**CHANGE ORDER NO. 02  
HANGAR SITE IMPROVEMENTS  
TRI-COUNTY AIRPORT (KBCR), FLORIDA**

**ENGINEER'S SUPPLEMENTAL INSTRUCTION (ESI)**

Airport	Tri-County Airport (KBCR)	ESI#:	03
Project	Hangar Site Improvements	Date:	12/02/2025
Engineer	AVCON, INC.		
Contractor	Gum Creek Farms, Inc.

**UNDERCUT AND UNDERDRAIN PLAN & DETAILS**

New Sheet C-11A

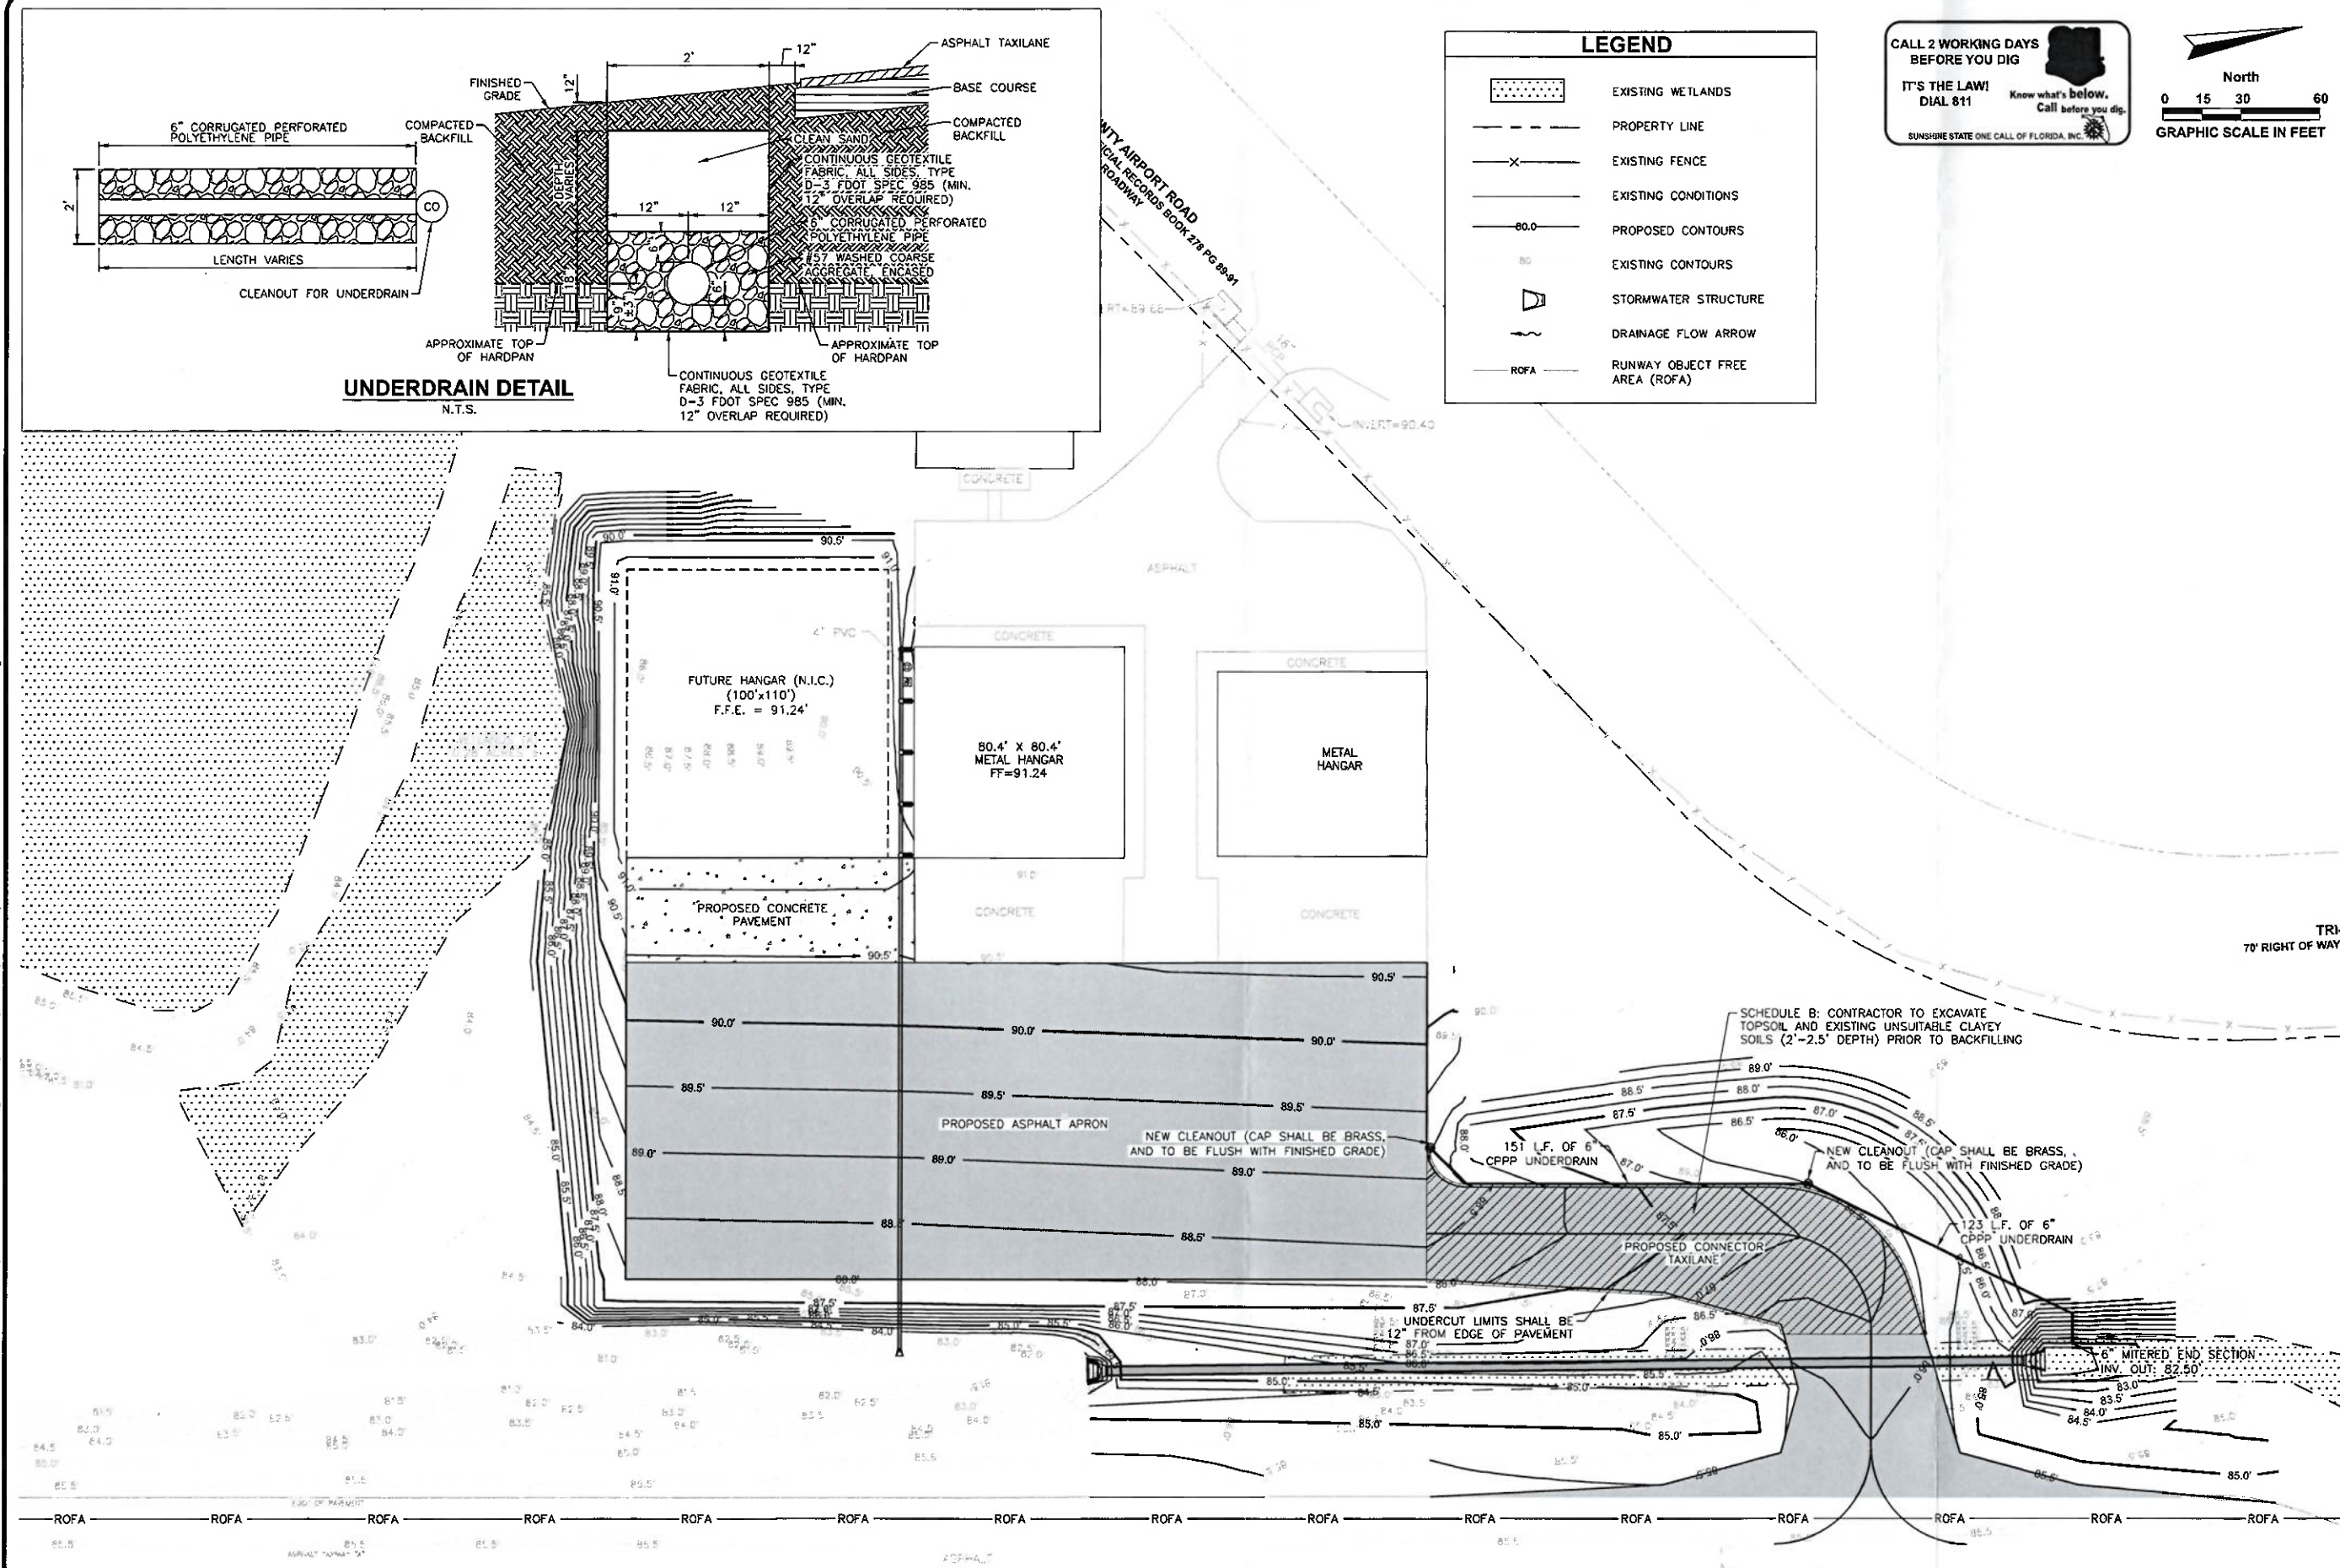
This ESI adds new sheet C-11A which includes direction on new scope for Schedule B:

1. Over-excavate the new taxiway connector subgrade (west of the ditch; to the limits shown on C-11A) a depth of 2-2.5 ft to remove unsuitable soils. All costs associated for this work, including excavation, backfilling with suitable material (i.e. LBR  $\geq$  40), and compacting to required densities shall be included in the lump sum price for Schedule B Pay Item 120-4 **Taxiway Subgrade Over-Excavation**.

2. Install 6" underdrain west of new taxiway connector pavement per plan and details on C-11A. The bottom of the underdrain shall be notched into the underlying hardpan as shown in the details. All costs associated for this work, including excavation & backfilling and furnishing & installing all perforated pipe, clean-outs, clean sand, geotextile fabric, and mitered-end section shall be included in the lump sum price for Schedule B Pay Item 430-6 **6" Underdrain** to be added through change order.
